Time to take a stand – the proposed new Ben More hydro track

Address: Benmore Farm Crianlarich Stirling FK20 8QS

Proposal: Construction of a run of river hydropower scheme

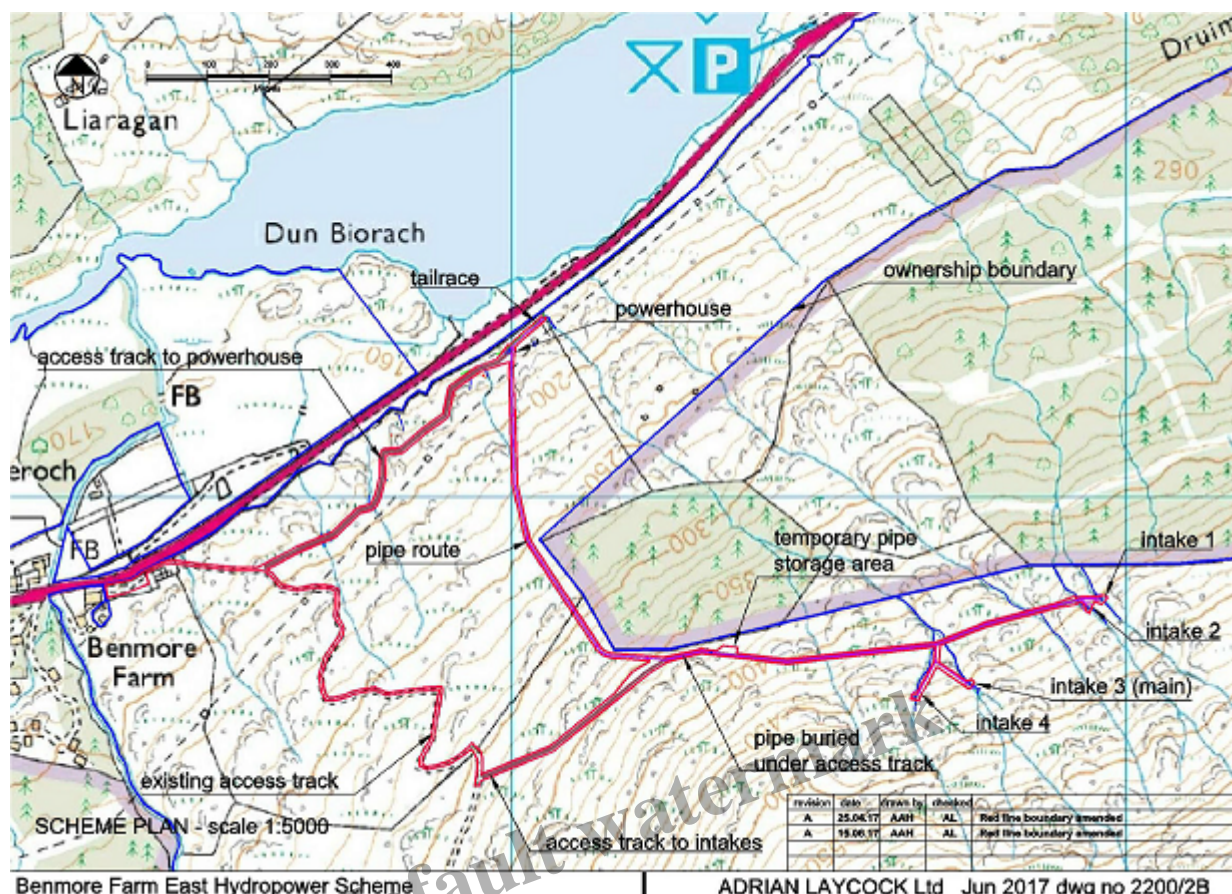
When you approach the intake though the most obvious feature is the metal fencing – contrary to Park guidance on use of natural materials (but is it really necessary?) – and the Lomond blue pipe. Its a shame that the left side of the intake has not been finished like the right had side but it does show, I think, what can be done. Well done somebody!

The recovery of the ground above the pipeline and construction track is not as good as it might have been because vehicles have been driven over land which is far too wet to support them.

Part of the Allt Essan hydro scheme on the north side of Glen Dochart – powerhouse centre

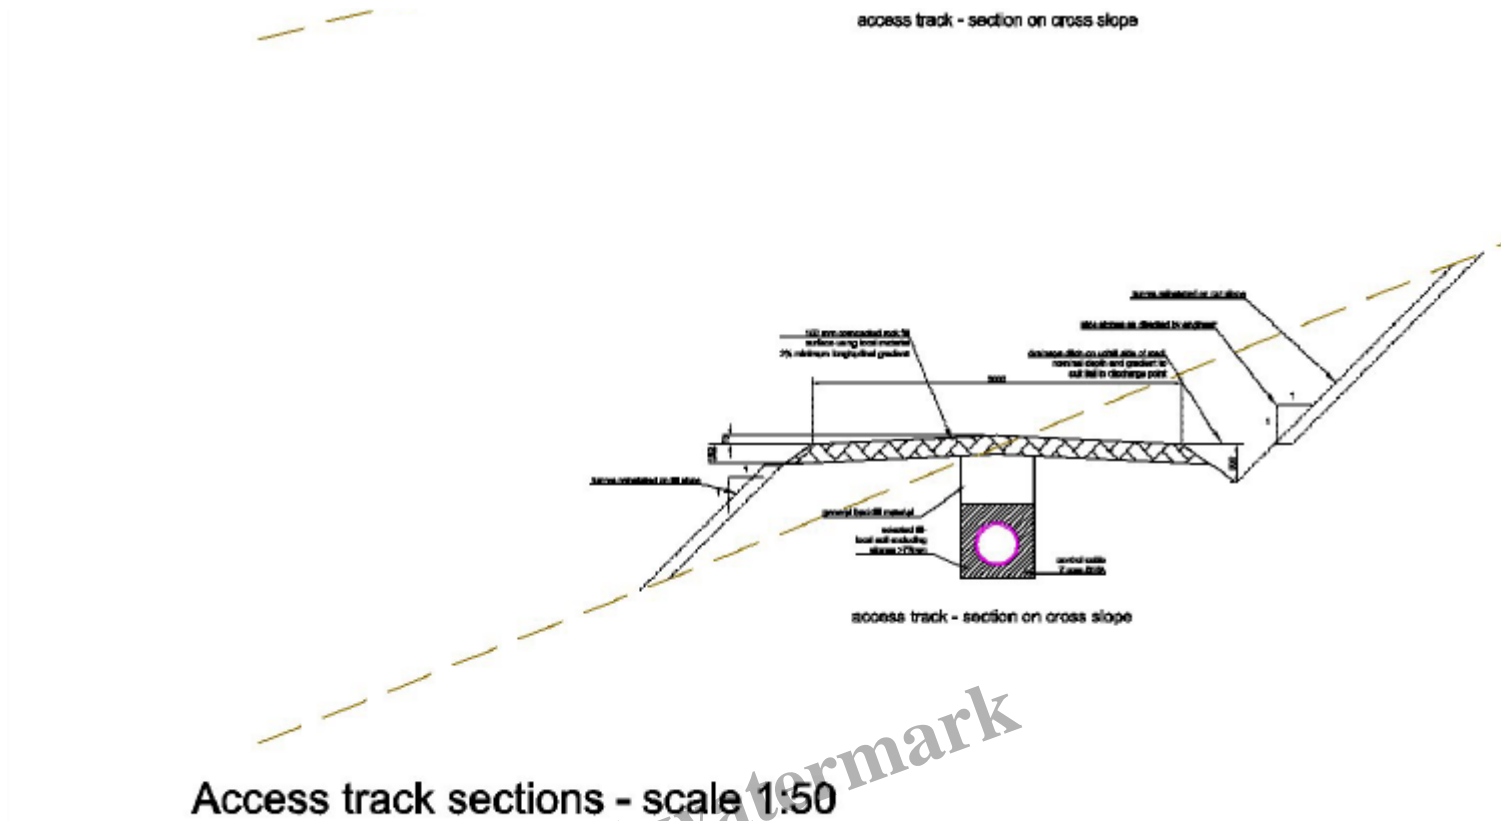
So, if other people are getting away with it, why should Benmore Farm follow best practice? That's why people need to take a stand. The proliferation of hill tracks is destroying the landscape in the National Park – and indeed across Scotland – and those who care about the landscape need to put a stop to this.
